# INTAKE SUBSTATION DEVELOPMENT PLAN

## REV G MINOR AMENDMENT - MINISTERIAL SUBMISSION

TAS-CYP-ARD-AIS-PLA-XLP-AEN-X0864

Monday, 4 September 2024

Figure 3: Location of the proposed feature fence

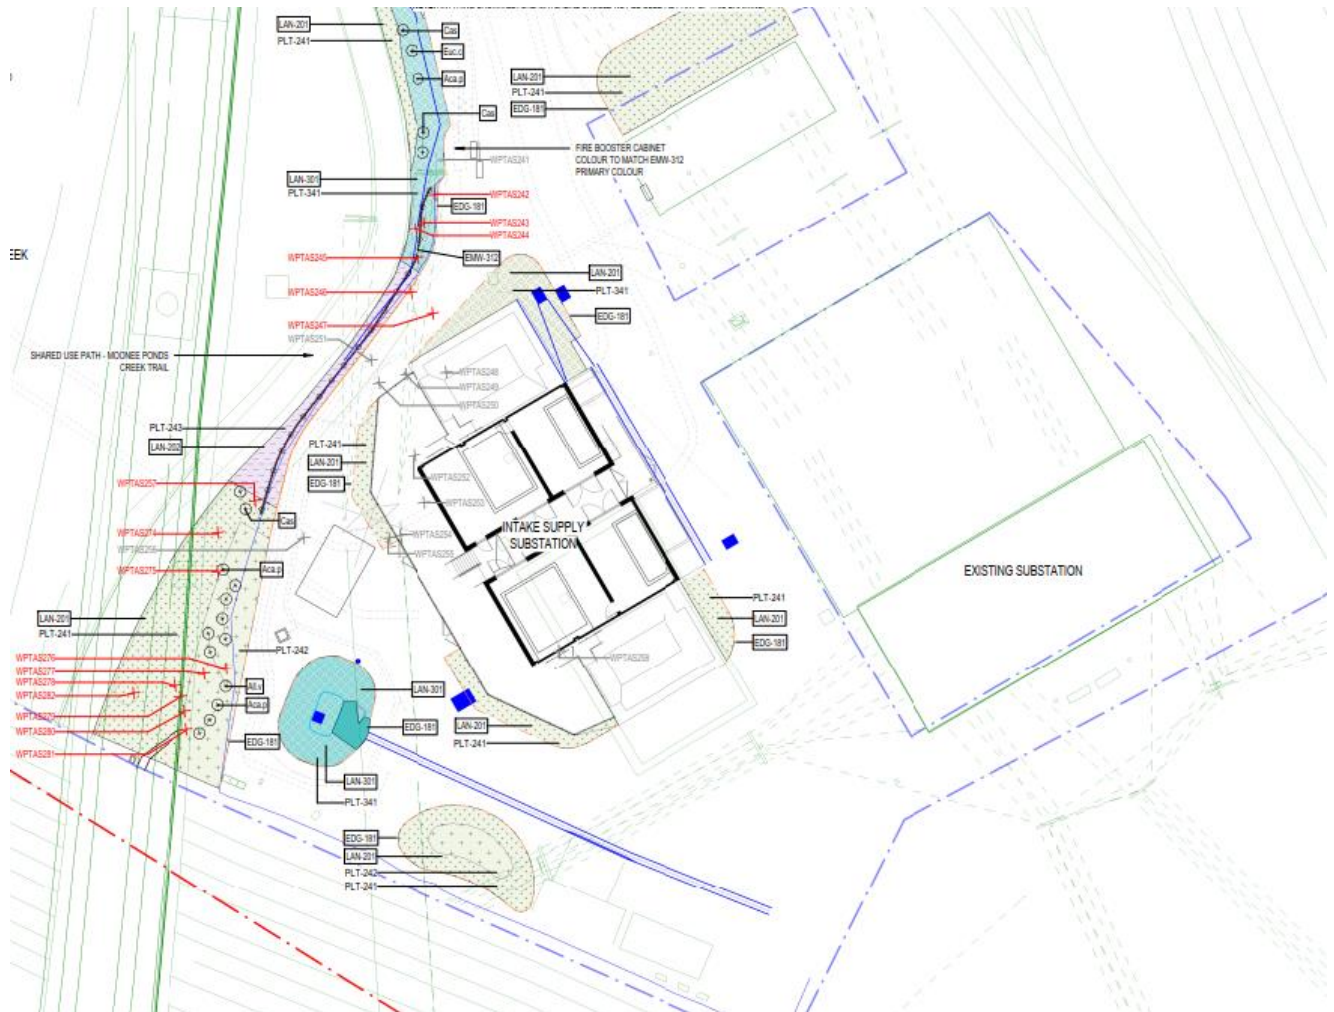
As part of the detailed design, CYP investigated options to further minimise impacts to the potential users of the Moonee Ponds Creek Trail. The amended design proposes a high feature fence adjacent to the trail. The fence is proposed in an irregular form with a pink/purple colour and white chevron finish. The proposed fence will promote permeability and provide clear sightlines to the

Intake Substation. The location of the proposed feature fence is shown in red on Figure 3. Further fence details are shown in Appendix C:
